**SUBJECT:** NuScale Power, LLC Submittal of the Approved Version of NuScale Topical Report TR-0616-48793, "Nuclear Analysis Codes and Methods Qualification," Revision 1

NuScale Topical Report, TR-0616-48793-P-A, "Nuclear Analysis Codes and Methods Qualification,"  
Revision 1, proprietary version

SUBJECT: FINAL SAFETY EVALUATION FOR NUSCALE POWER, LLC TOPICAL REPORT-  
0616-48793, REVISION 1, "NUCLEAR ANALYSIS CODES AND METHODS  
QUALIFICATION"

Figure 3-5. SIMULATE5 Radial Reflector Region Diagram

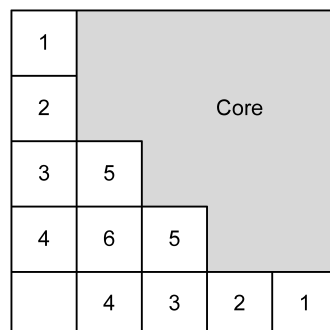
During a regulatory audit, the NRC staff asked the applicant to clarify the radial reflector modeling approach as presented in Figure 3-5 of the TR (Reference 13). The applicant explained that the modeling of the radial reflector in the NuScale RXC is split into multiple segments matching the square array and pitch of the fuel assemblies. The applicant identified radial reflector segments according to their position around the core and the relative material composition of the segment, as shown in Figure 3-5 of the TR. Each unique radial reflector segment has different relative proportions and locations of stainless steel and water and thus has different reflection capability. In Figure 3-5 of the TR, only reflector segments 1, 2, and 5 are adjacent to a fuel assembly. However, the method of modeling each reflector segment in CASMO5 requires an adjacent fuel assembly to provide a source of neutrons. The applicant modeled the radial reflector with multiple concentric reflector segments that are modeled in CASMO5 using the same technique. The applicant explained that the radial reflector modeling is performed in this manner in order to maintain fidelity of the reflector regions that are closest to the core while aligning the fuel submesh, radial reflector submesh, and neutronic distinct layers of the radial reflector. The NRC staff finds the applicant's approach to modeling the radial reflector acceptable because it explicitly captures the neutronic distinct regions of the radial reflector.
